KNOCKING NOISE FROM FRONT SUSPENSION WHEN DRIVING OVER BUMPS AT LOW SPEEDS

Bulletin No.: 02-017/18

2016-2017 Mazda2 (Mexico spec)

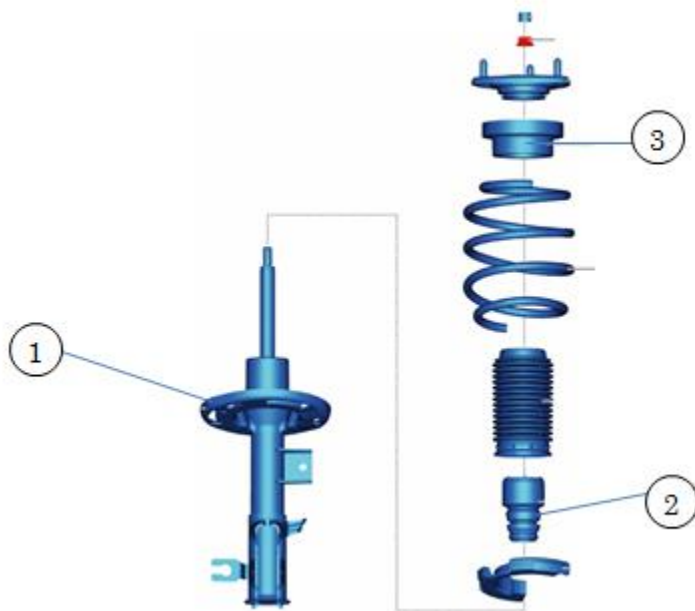
Some vehicles may experience one or both of the following noises from the front shock absorber.

- A knocking/popping noise occurs when passing over speed bumps.
- A squeaking noise occurs when turning the steering wheel with vehicle at a standstill or at low speed.

This is caused by the bump stopper (2) contacting the strut bearing (3) when the front shock absorber (1) is compressed.

To eliminate this concern, the shape of the bump stopper has been modified.

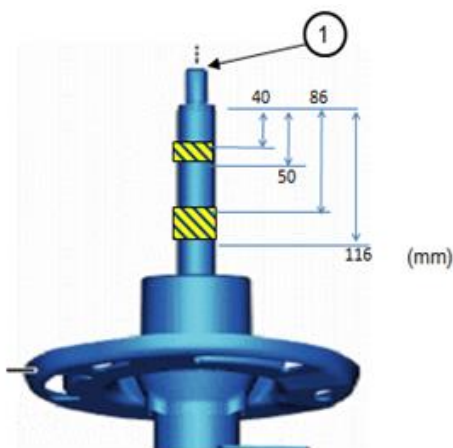
4. Apply approx. 3 - 5 gram of rubber grease on the hatched areas as shown (all the way around).

NOTE: DO NOT apply grease on the threads (1).
